Re: BusConnects Lucan to City Centre Core Bus Corridor Scheme
Lucan to Dublin City Centre

OBSERVATION IN RELATION TO
LANDS AT KNOCKMAREE, ST. LAURENCE'S ROAD,
CHAPELIZOD, DUBLIN 20

LUCAN TO CITY CENTRE CORE BUS CORRIDOR SCHEME
COMPULSORY PURCHASE ORDER 2022

PLOT REFERENCE NO. : 1023(1).1f & 1023(2).2f

Excerpt from Lands to be Compulsory Acquired Deposit Map (Sheet 10 of 13) (Drawing no. DR-GG-010)

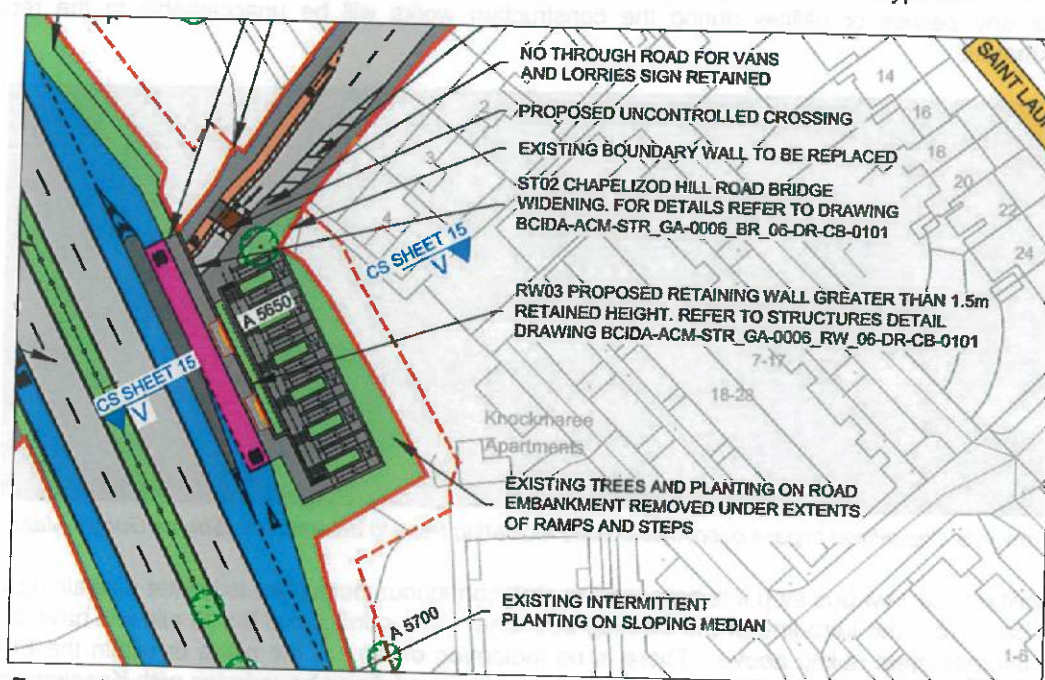
- 1.2 This report will address the area of land to be permanently acquired by the NTA that amounts to an area of 856.3sqm under Reference 1023(1).1f; and a smaller piece of land of 440.6sqm under Reference 1023(2).2f that is to be temporarily acquired to facilitate these works. The Order Schedule that accompanies the CPO indicates that Dublin City Council are also owners of part of these land acquisitions. It is our understanding that their ownership relates to a small portion adjacent to the Chapelizod Hill Road. This report will detail the negative impact of the construction and operational phase of the Proposed Development will have on our client's properties within Knockmaree. The report will also outline the negative impact the loss of trees and amenity lands will have on the value of the various duplex units and apartments within Knockmaree.

- 2.7 The lands that are the subject of this Compulsory Purchase Order (CPO) on a permanent and temporary basis are indicated on the Lands to be Compulsory Acquired Deposit Map (Sheet 10 of 13) (Drawing no. DR-GG-010), an excerpt of which is indicated below.

Excerpt from General Arrangement Drawing (Sheet 20 of 31) (Drawing no. DR-CR-020)

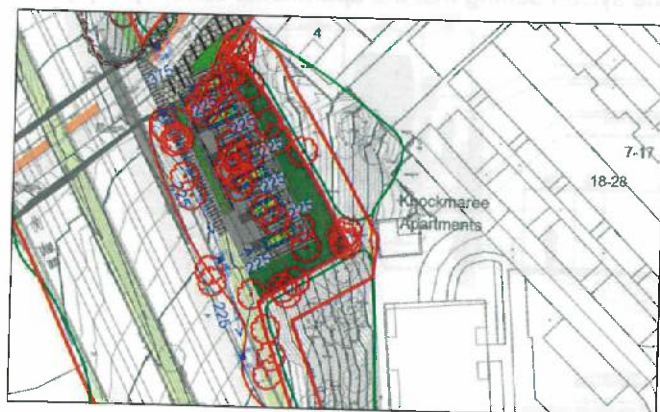
- 3.3 The nature of the works at and adjacent to the Knockmaree apartments are shown on Drawing no. DR-CR-0020 (Sheet 20 of 31), an excerpt of which is provided on the following page. All works are proposed in this location to the immediate north-west of the Knockmaree development to facilitate east bound traffic. These works are described within section 4.5.2.1 of Chapter 4 of the Environmental Impact Assessment Report (EIAR) as being:

- 3.4 The scale, form as well as the nature and extent of the steps and ramp is notable in seeking to facilitate the c. 10m height differential. This creates a heavily engineered solution that includes 18 ramps to provide wheelchair / pushchair access to the proposed new bus stop that is located on the proposed widened bridge and to the immediate west of Knockmaree. The geographical position and location of the ramps must also be considered in that in order to access them a person would need to push up the 110m steep slope from St. Laurence's Road. Irrespective of the benefits in terms of access for all, it is highly questionable of how often the ramps would be used in this instance given that a high frequency bus service exists through Chapelizod Village (Bus route no. 26) and the relatively short distance to the city centre; and the lack of residential development to the west side of the bypass.

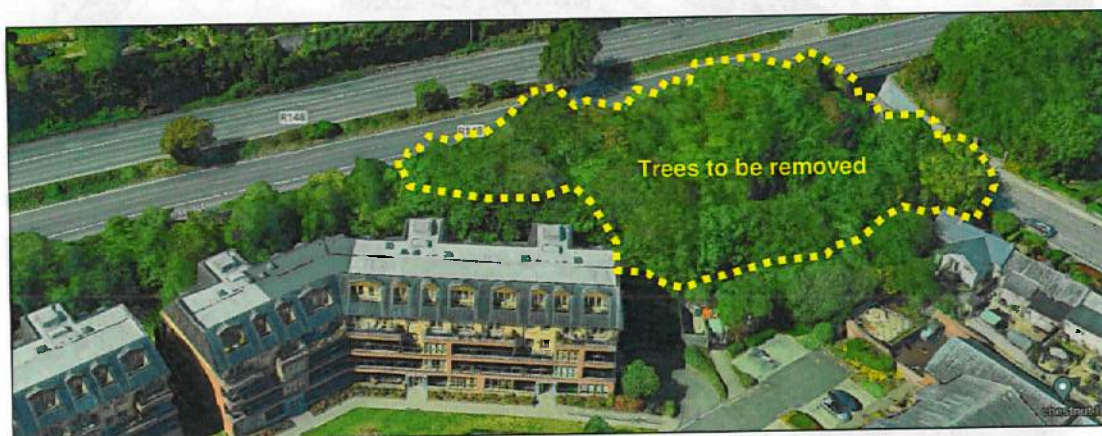
- 3.5 The proposed works is indicated as resulting in the loss of c. 40 mature trees. These are indicated within the Arboricultural Impact Assessment as being 'Unsurveyed existing tree features to be removed'. Their proposed removal and impact has therefore not been accurately assessed within the accompanying EIAR that forms part of the CPO. The trees indicated for removal are shown at the top of the next page in red.

3.6 The drawing (Drawing no. DR-LL-0020 (Sheet 20 of 31) does not adequately indicate the tree cover on the steeply sloping lands, and the extent of the tree cover that will be lost. Assuming that all trees will also be removed within Temporary CPO lands, to facilitate the heavy engineered ground works and supporting structure proposed, we have estimated that all bar the lowest trees will be lost. This is based on a retaining structure being required within a few metres of the substation, and the Temporary CPO extending a corridor around these works to facilitate them. This will have a profound negative impact on the visual amenity and feeling of privacy within Knockmaree.

View towards Chapelized bypass over Knockmaree indicating trees to be removed (Source Google Maps and CPO)

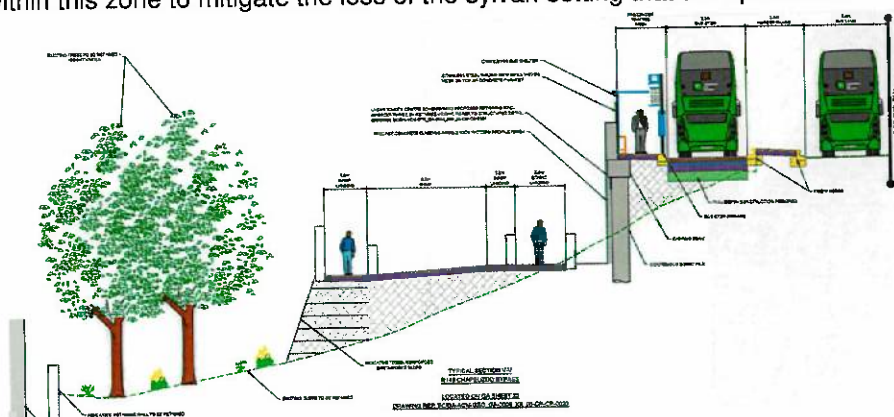
3.7 There are no details within the Arboricultural Impact Assessment that forms Appendix A17.1 of the EIAR, on the species, quality, condition, spread or maturity of these trees, and therefore their categorisation has not been adequately considered within the EIAR. We respectfully submit that the conclusions of the Arboricultural Impact Assessment within the EIAR are therefore deeply flawed. The hard nature of the works and removal of green infrastructure will also have a significant negative impact on the biodiversity of the area. It is also our understanding that a number of services and utilities run beneath the ground adjacent to the boundary with Knockmaree that will be impacted, and will need to be relocated by the proposed development. Any loss of any service or utilities during the construction works will be unacceptable to the residents of Knockmaree.

Excerpt from Map D of the new Dublin City Development Plan 2022-2028

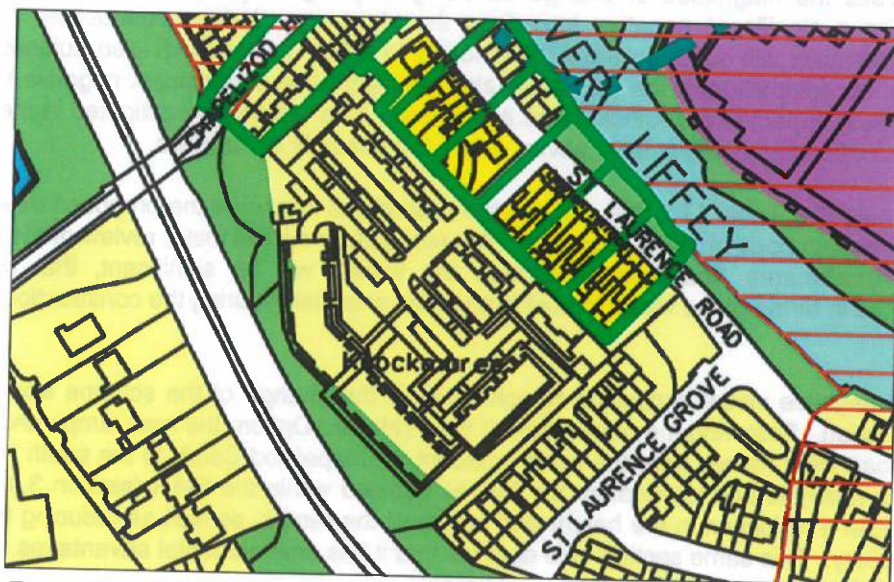
- 4.1 The subject site is governed by the Dublin City Development Plan 2022-2028 and its requirements. Whilst the majority of the Knockmaree site is zoned Z1 to provide for Sustainable Residential Neighbourhoods; the triangular area that is subject to both the permanent and temporary CPO are indicated as being zoned as Z9 with the objective to provide for Amenity / Open Space Lands / Green Network. The role of Z9 lands is to improve biodiversity and ecological connectivity, which the subject proposal is at complete odds to. Their purpose is also to provide enhanced nature based surface water management, flood attenuation, and climatic resilience. The design of the access to the proposed new bus stop is at complete odds with this objective.

- 4.2 It is notable that the boundary of an Architectural Conservation Area bounds the CPO lands along Chapelizod Hill Road (noted by the dark green hatch) with the Conservation Area (indicated by red hatching) that bounds the River Liffey also extending as far as the CPO lands.
